# FCC CLASS II PERMISSIVE CHANGE REQUEST LETTER

**RE: FCC Permissive II Change Request for Company: The Watt Stopper, Inc. FCC ID: Q4B-FSP-3X1**

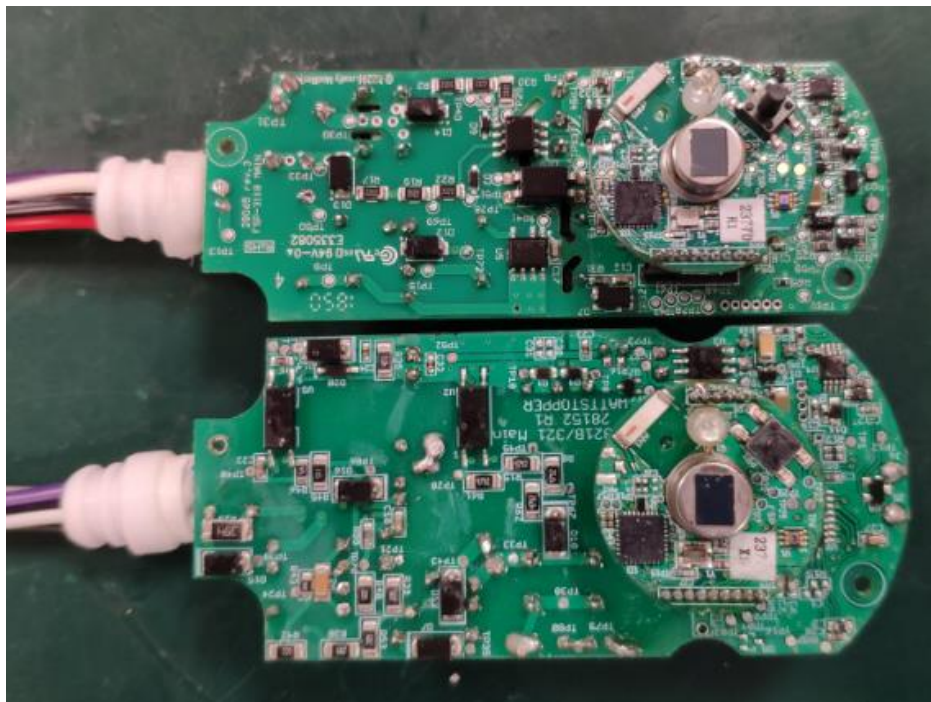
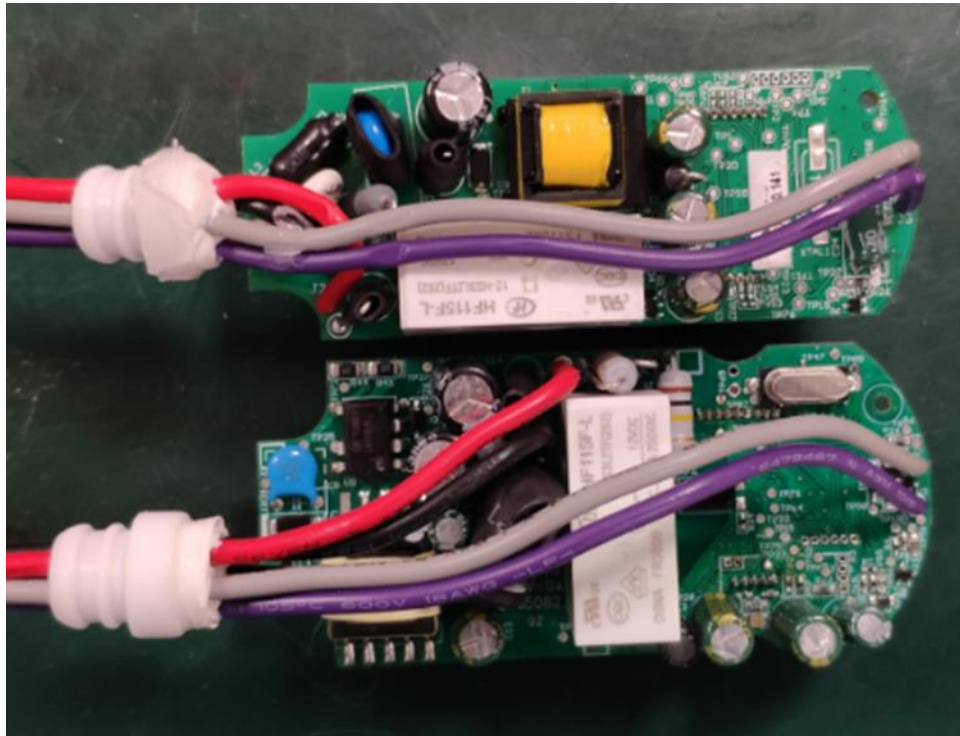
1. Change the design for AC to DC circuit;
2. Change the cross-zero sampling circuit;

Picture are show as below(above is new version, below is old version):
